#### 192nd session

## Proposal for Supplement 6 to the 00 series of amendments to UN Regulation No. 150 (Retro-reflective devices)

### Submitted by the Working Party on Lighting and Light-Signalling\*

“Figure A5-VII

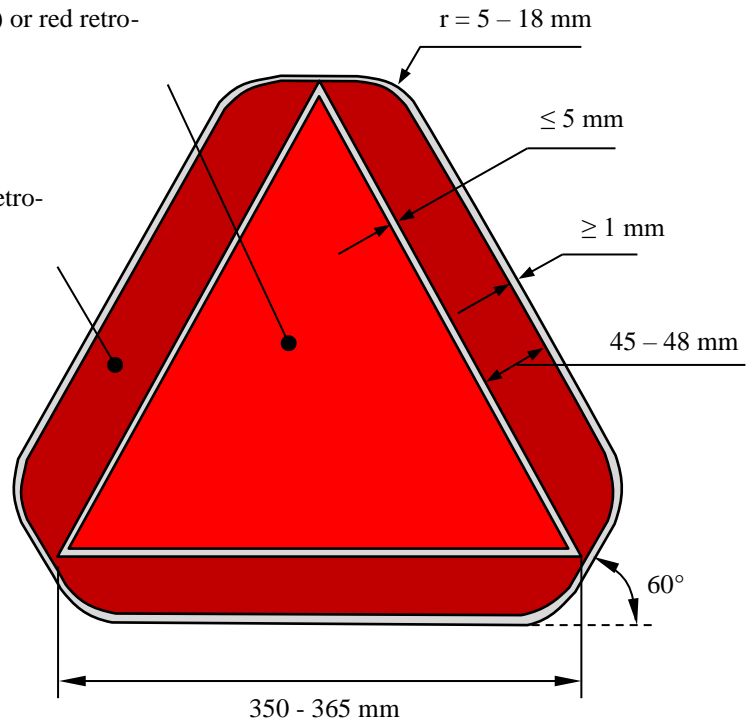
Paragraph 7.3., amend to read:

The length of the base of the enclosed fluorescent triangle (class 1) or retro-reflective triangle (class 2) shall be: minimum 350 mm and maximum 365 mm. The minimum width of the light-emitting surface of the red retro-reflective border shall be 45 mm, the maximum width 48 mm. These features are illustrated in the example of Figure A5-VII.”

Figure A5-VI “Example of a slow-moving vehicle plate”, amend to read:
